Addendum #1

Lewiston Readiness Center Roof Replacement Project
Project No. 23SR10-461-D, Bid Number #16-040

Directorate of Facilities Engineering

5 April 2016

SHEET ID:
 A-101
 SHEET: 4 OF 36

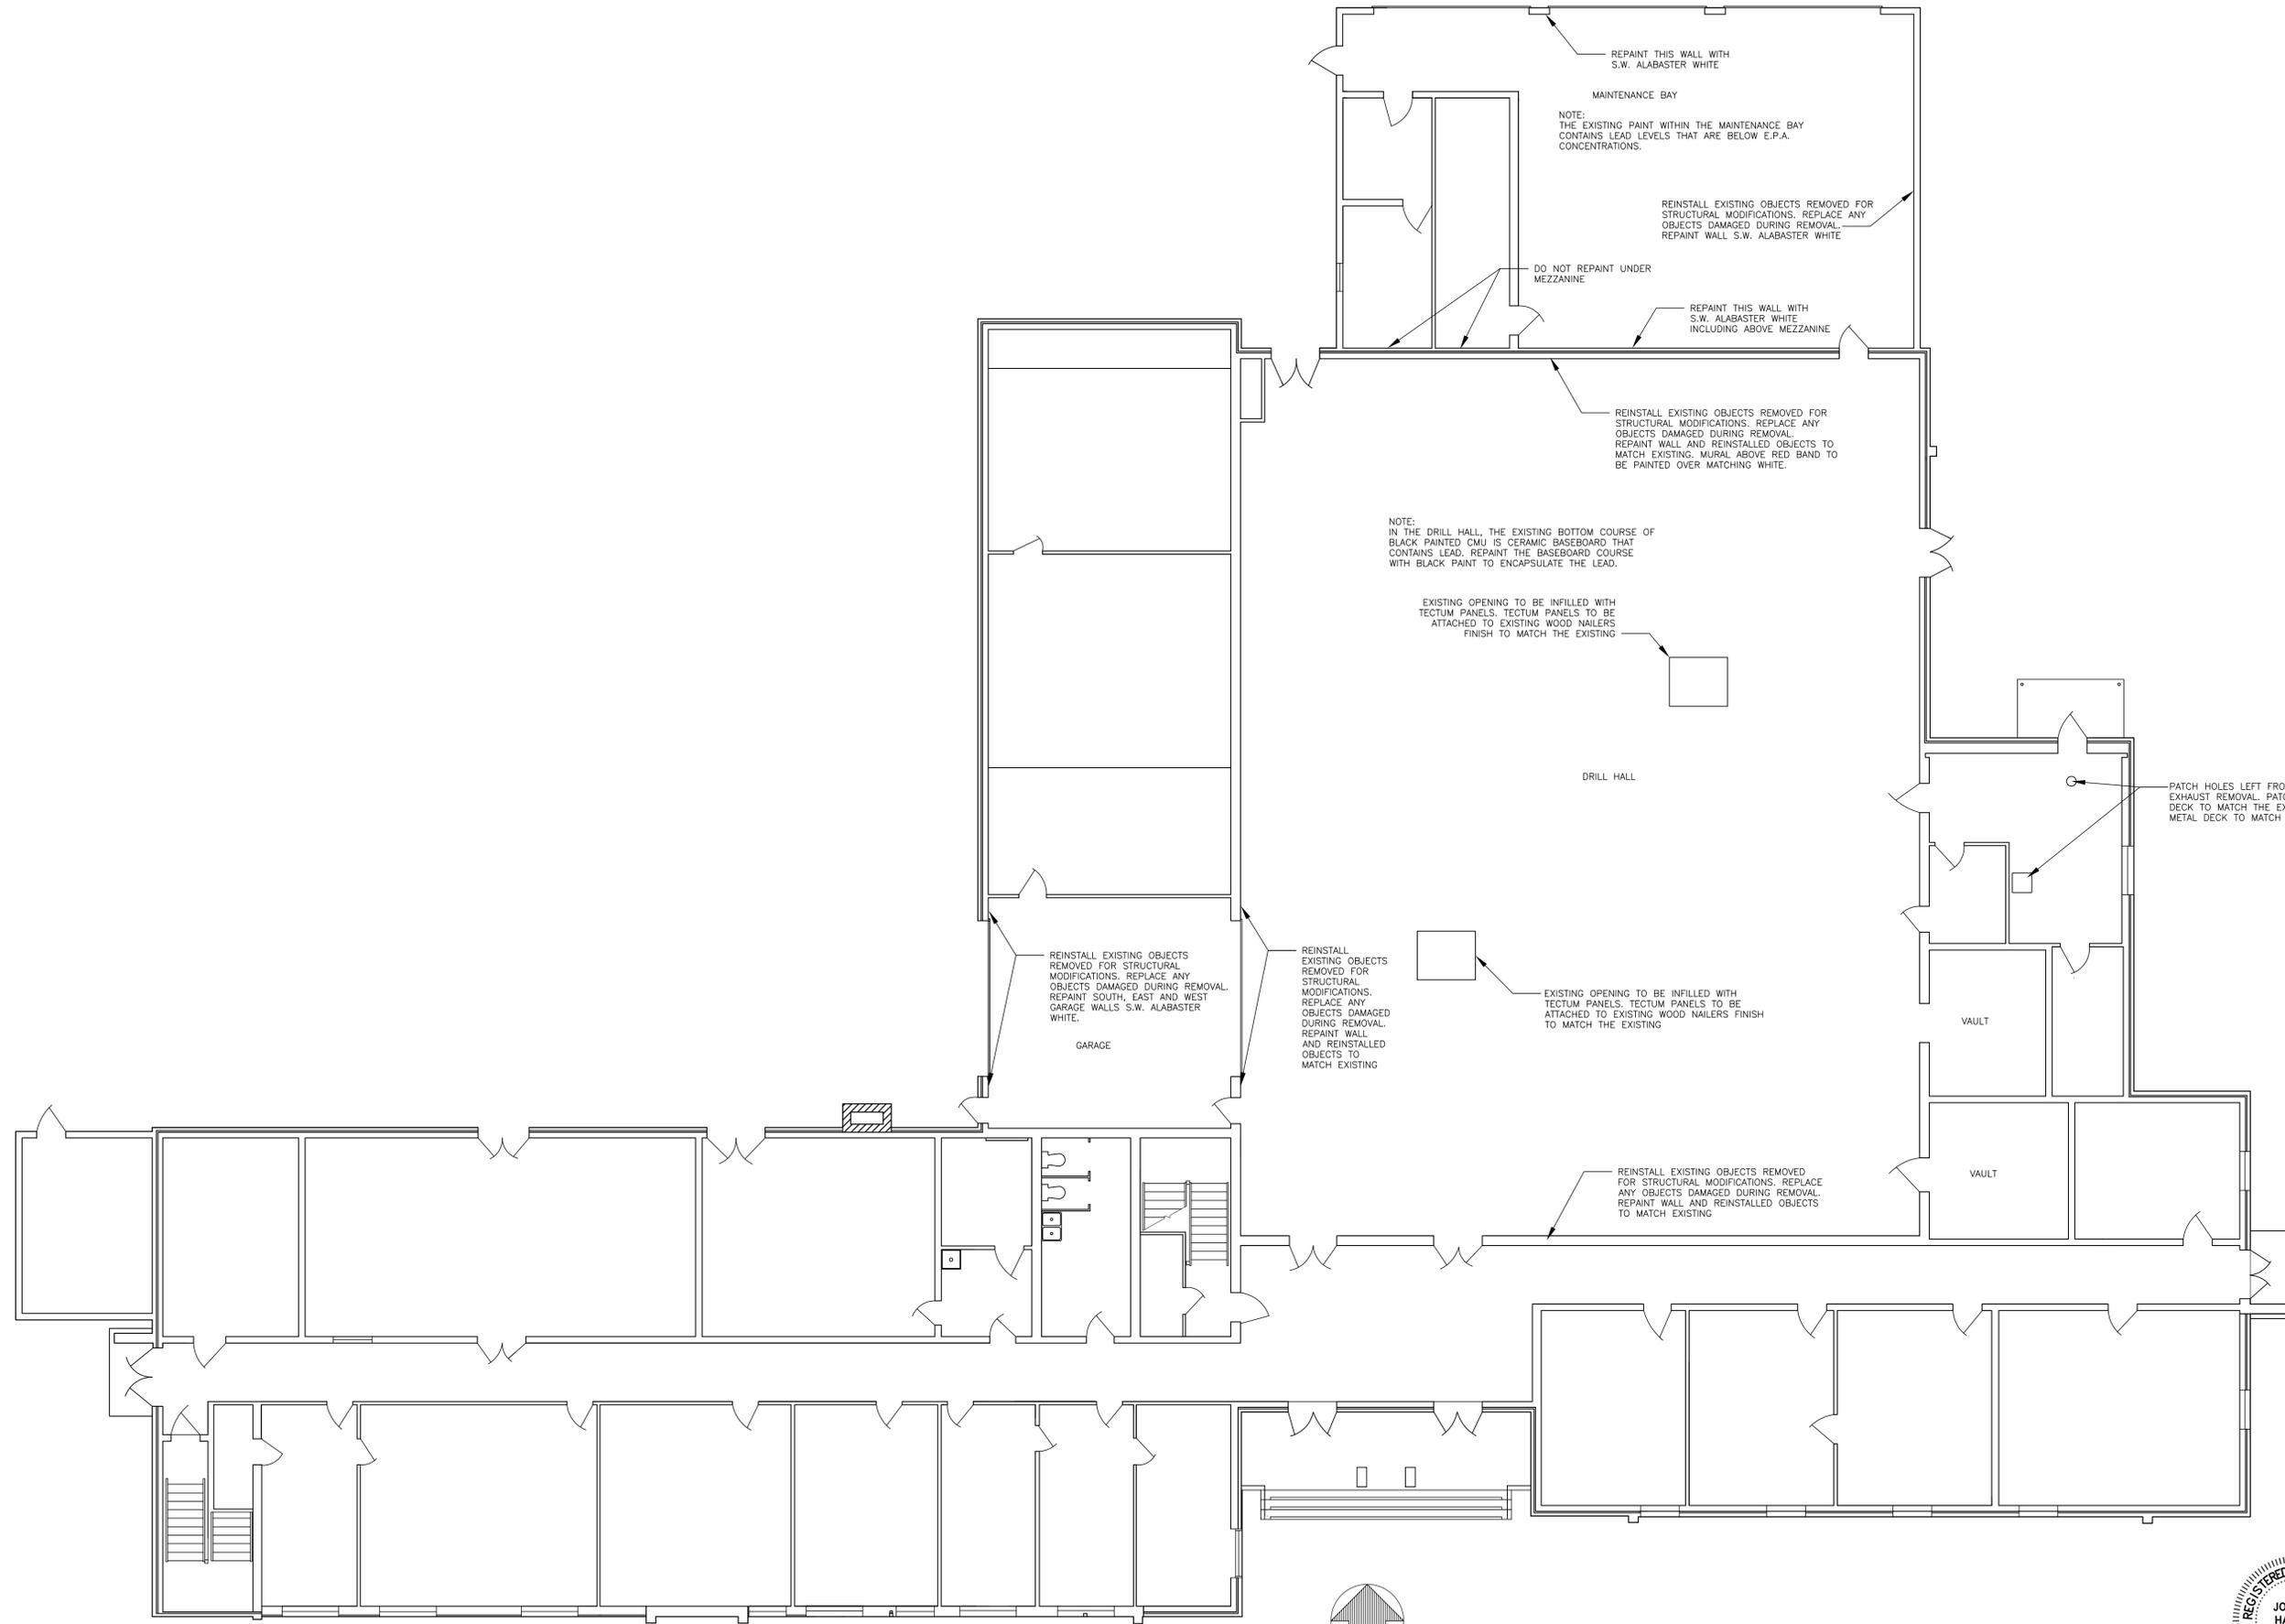
- (1) Sheet A-101: Removed notes from canopies to remain under this project.
- (2) Sheet A-102: Modified extent of repainting in Garage and Maintenance Bay.

SHEET ID:
 A-105
 SHEET: 8 OF 36

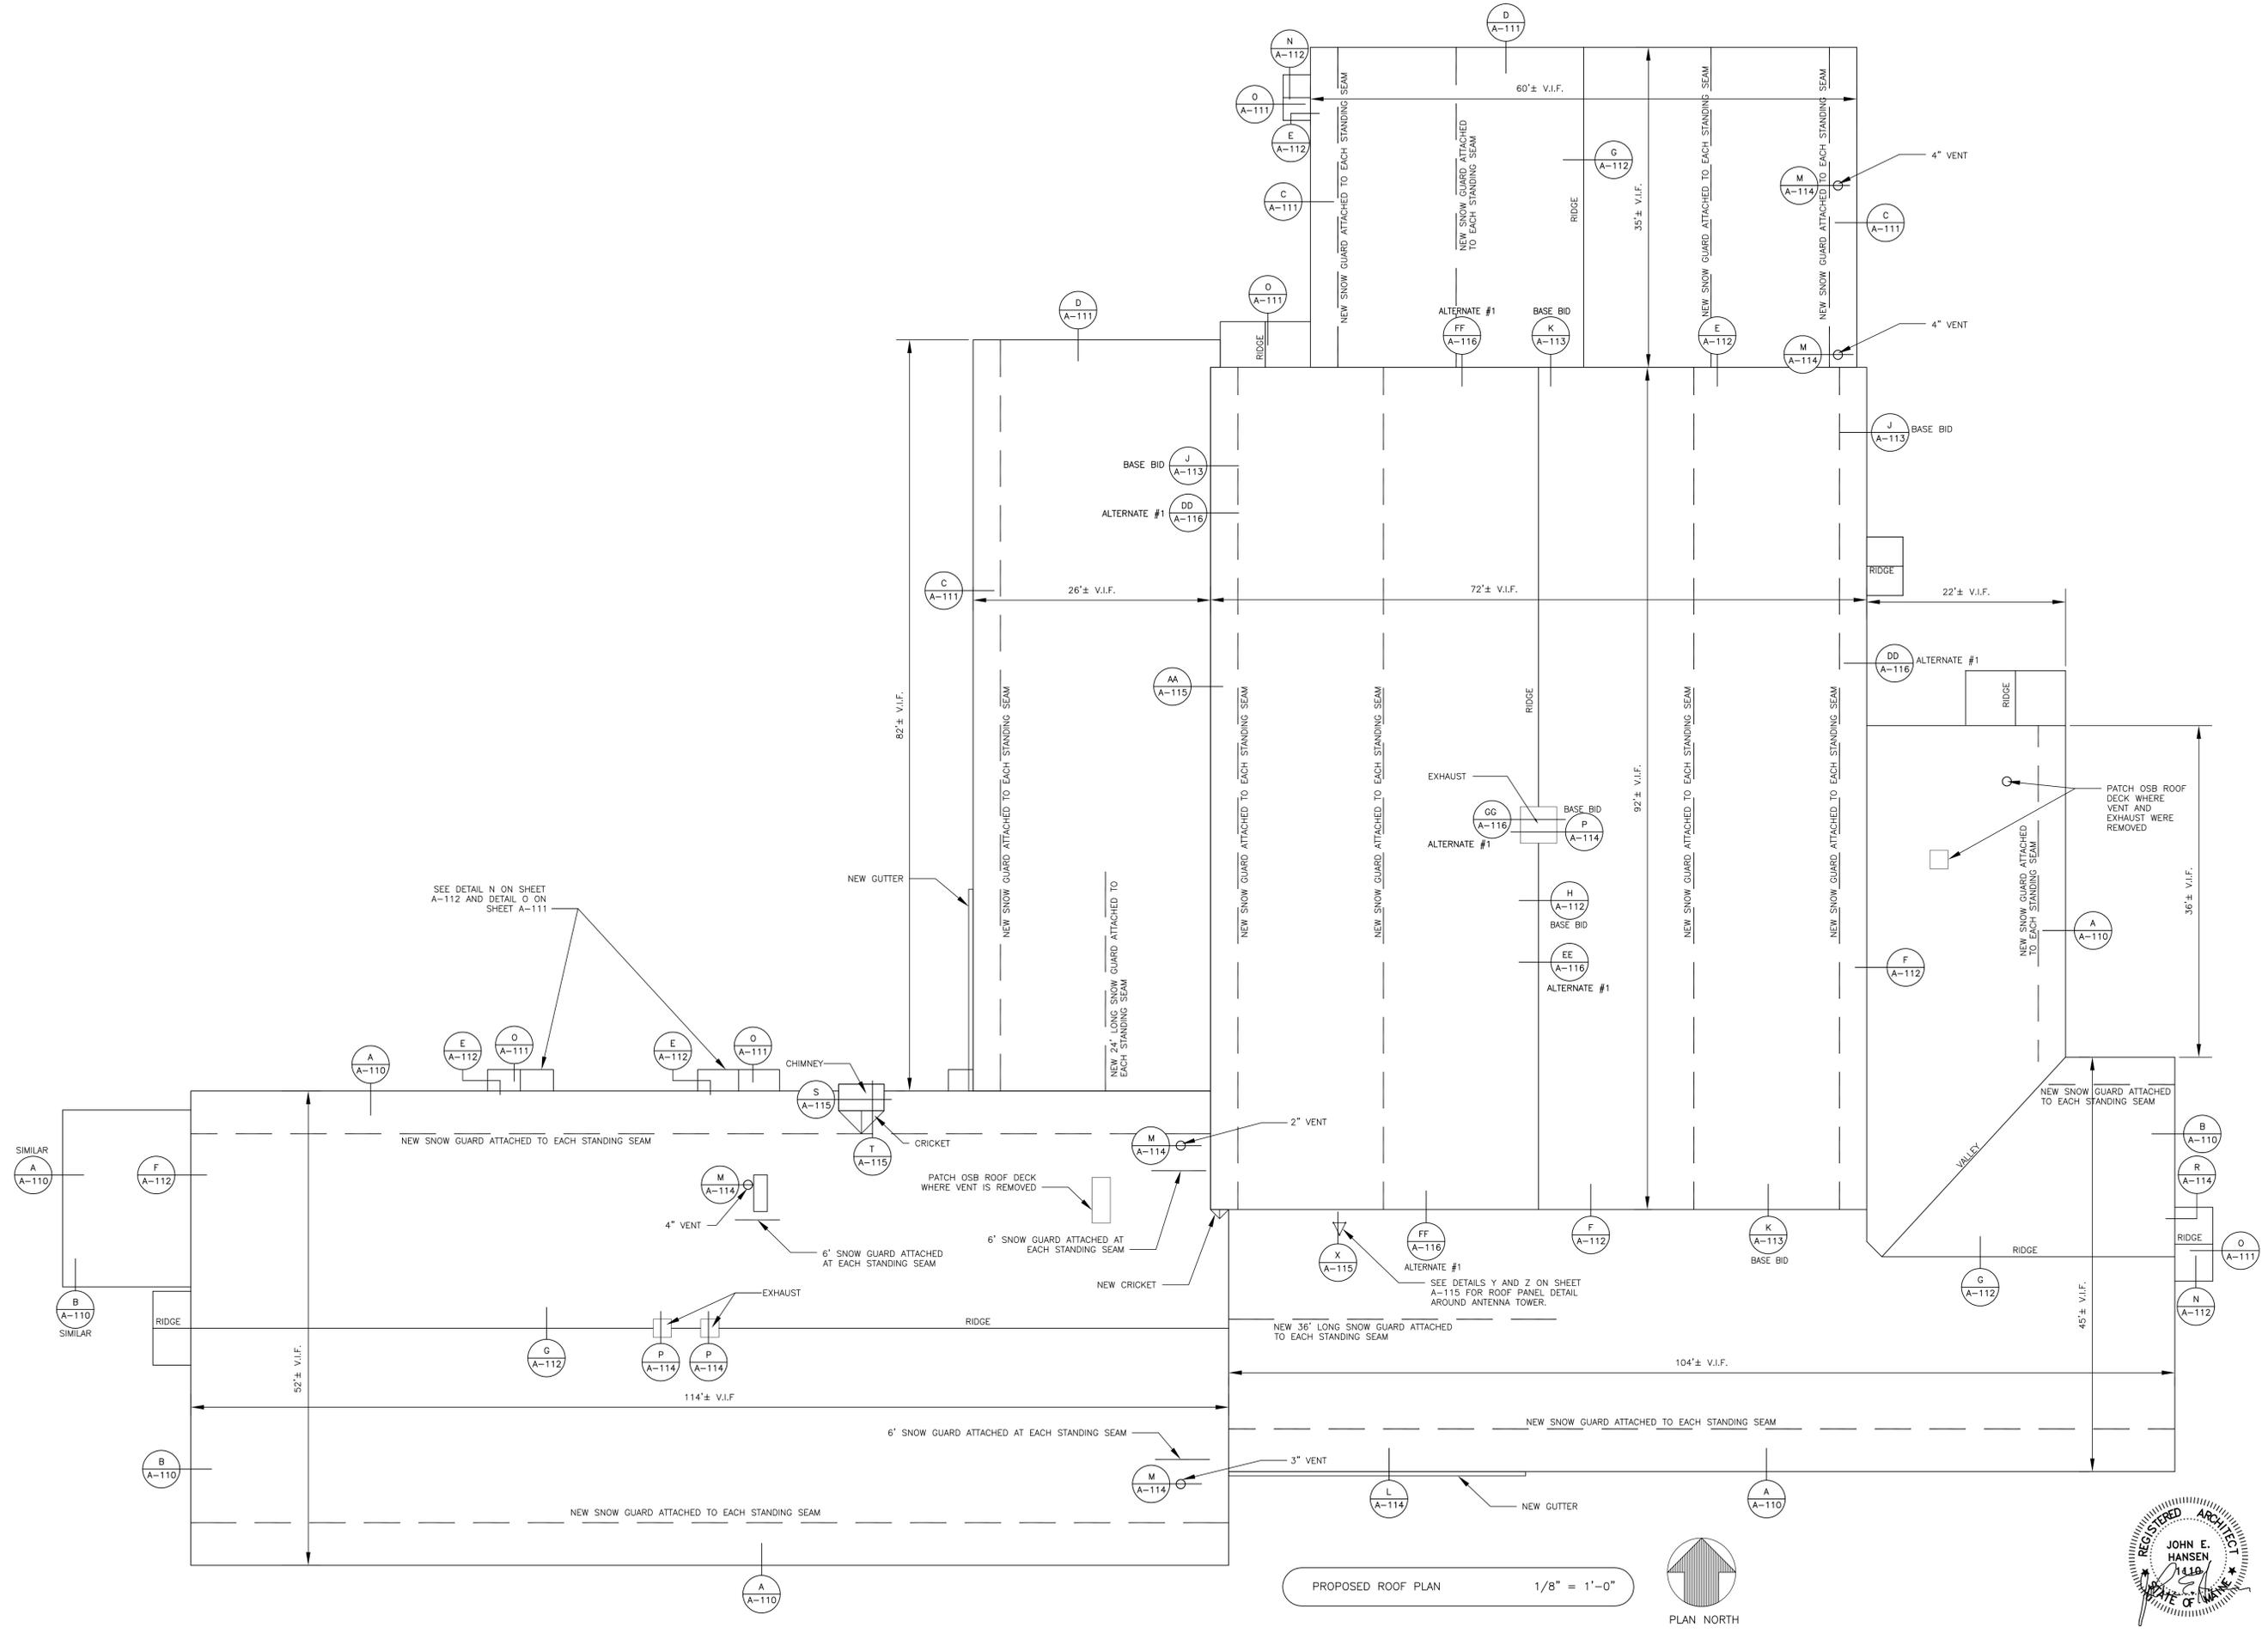
- (4) Sheet A-105: Removed work notes from canopies to remain under this project.
- (5) Sheet A-106: Removed demo notes from canopies to remain under this project.
